Amendments to the Drawings:

Remarks

Planar Systems, Inc.

FIG. 2

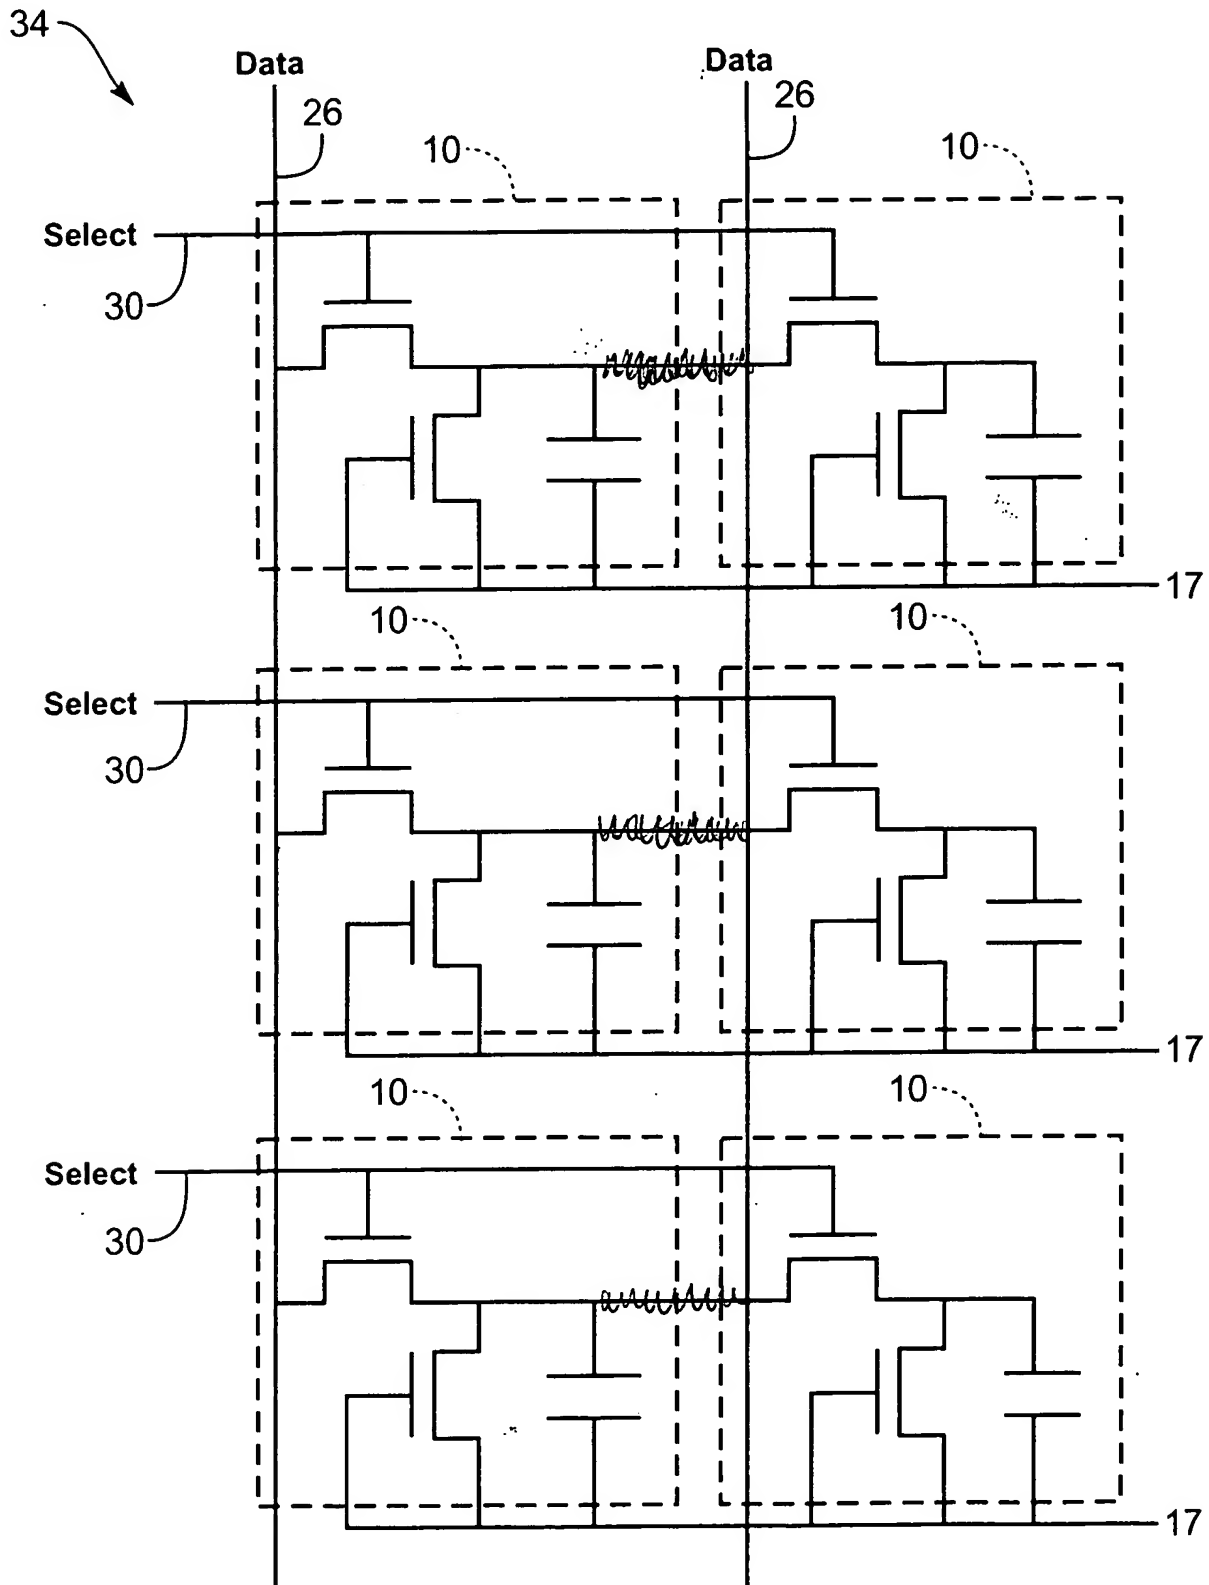
The attached sheets of drawings includes changes to Figures 2, 3, 4, 8, 10, and 13. These sheets replace the original sheets. In Figure 2, additional, erroneous lines are removed. In Figure 3, a structure is identified as "17" that was missing a label. In Figure 4, the identifier "12" has been added. In Figure 8, a missing line in the lower right capacitor in the Figure has been added. In Figure 10, extraneous identifier "124" has been deleted. In Figure 13, the chart title has been amended.
